PCN-20190110a TE0820-03-* SPI Flash and eMMC Change

Company	Trenz Electronic GmbH
PCN Number	PCN-20190110a
Title	TE0820-03-* SPI Flash and eMMC Change
Subject	BOM change
Issue Date	2019-10-02

This change affects Trenz Electronic TE0820-03 SoMs: TE0820-03-*

Locate Flash (U7, U17) on top side of PCB and eMMC (U6) on bottom side of PCB:

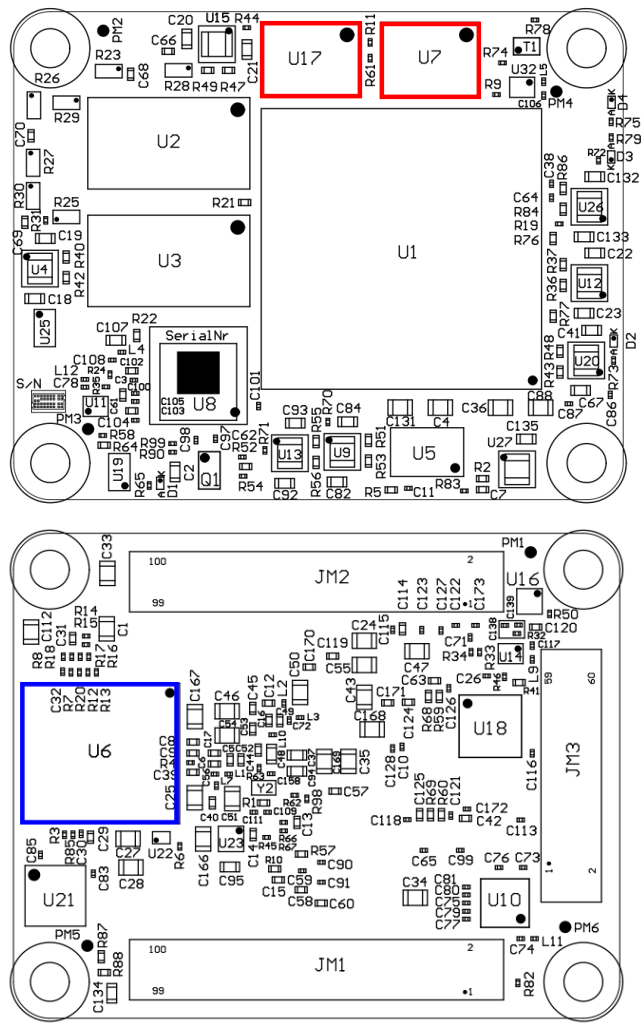
#1 Change SPI Flash from N25Q512A11G1240E to MT25QU512ABB8E12-0SIT

Reason: N25Q512A11G1240E became obsolete.

Impact: None. Both have same JEDEC ID BB20h and manufacturer ID 20h.

old	new
N25Q512A11G1240E	MT25QU512ABB8E12-0SIT

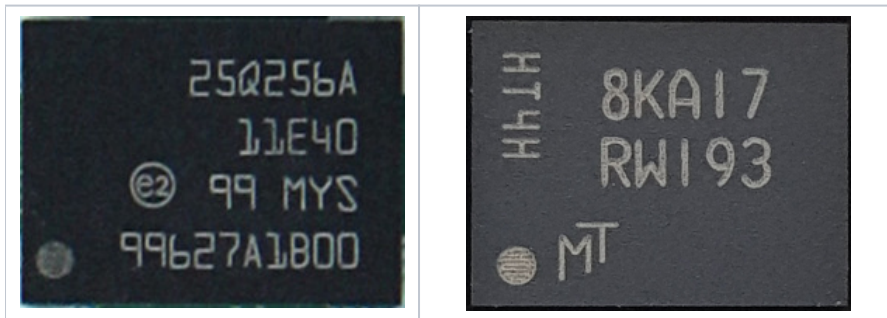
#2 Change eMMC from MTFC4GACAJCN-4M IT to IS21ES08G-JCLI

Reason: Improve availability.

Impact: The eMMC capacity changed from 4 GByte to 8 GByte.

MTFC4GACAJCN-4M IT	IS21ES08G-JCLI
